CERTIFICATE OF APPROPRIATENESS

Property: 408 Highland Street, Tracts 2 & 3A, Block 15, Woodland Heights Subdivision. The property includes a historic 1,279 square foot, one-story wood frame single family residence and detached garage situated on a 5,000 square foot (50' x 100') interior lot.

Proposal: Alteration – Construct a rear enclosed porch, relocate an existing sash window, and install new sash windows

EAST SIDE ELEVATION

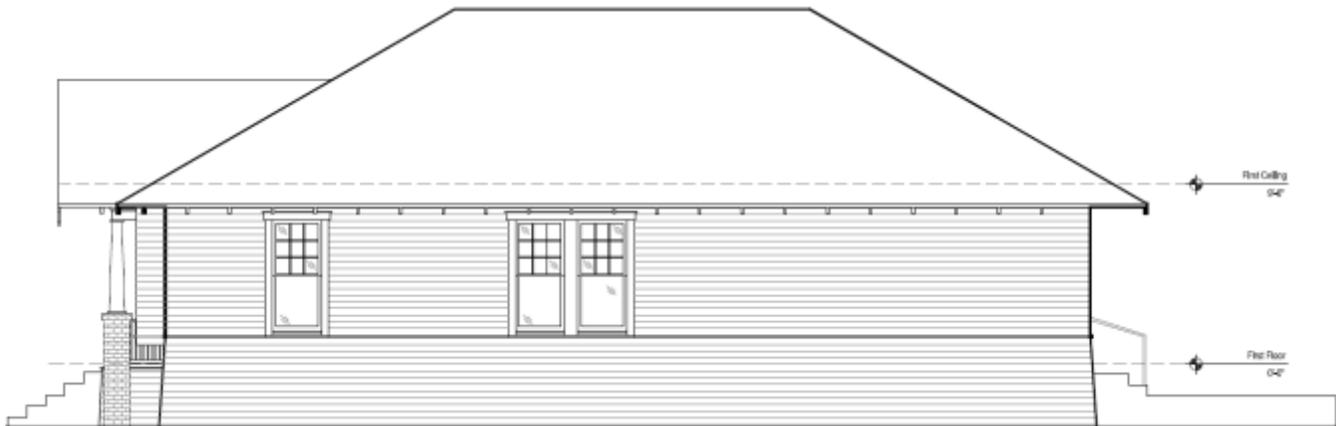
<i>The relocation and installation of new windows requires the creation of new window openings. The new openings result in the significant loss of original historic siding and historic shiplap. The relocation of windows and the installation of new windows that result in new window conditions impact the historic character of the contributing historic residence. The horizontal orientation of the proposed fixed single lite window on the east elevation is not compatible with the vertical proportions of the existing historic windows. A compatible window would be a square fixed window, a smaller sash window, or a fixed window that shares the proportion of the top sash of the existing historic windows.</i> | |

Side Elevation (East): The residence features two sets of two 9-over-1 windows, the southern set of windows will be split and one window will be relocated to the southeast corner. Install a new single lite fixed window.

- Only one 9-over-1 sash window is installed on the south side of an existing 9-over-1 sash window located on the northwest corner of the west elevation, instead of the proposed two sash windows.
- The proposed fixed sash window located on the east elevation be either a square fixed window, a smaller sash window, or a fixed window that shares the proportion of the top sash of the existing historic windows.

WEST SIDE ELEVATION

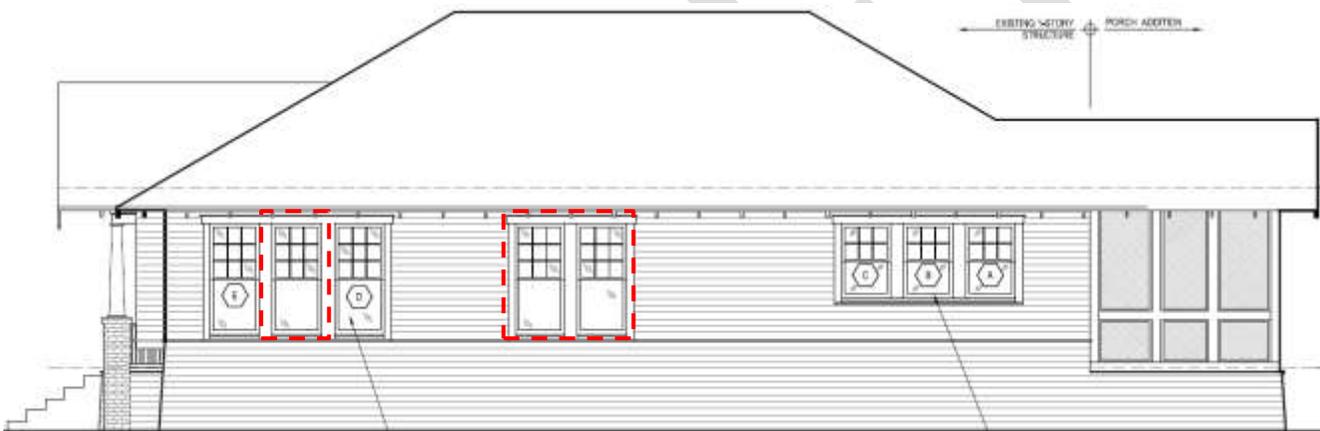
<i>The installation of two new windows on the north and south side of the existing window located on the northwest corner of the west elevation introduces a new architectural feature, a ribbon of three sash windows, which is not present on the 1915 Craftsman residence. The typical window condition found on the residence is single sash windows or pairs of two sash windows.</i> | |

Side Elevation (West): The residence features three 9-over-1 windows. Install two new 9-over-1 windows on the north and south sides of an existing 9-over-1 window located on the northwest corner. Install a ribbon of three 6-over-1 windows on the southwest corner.
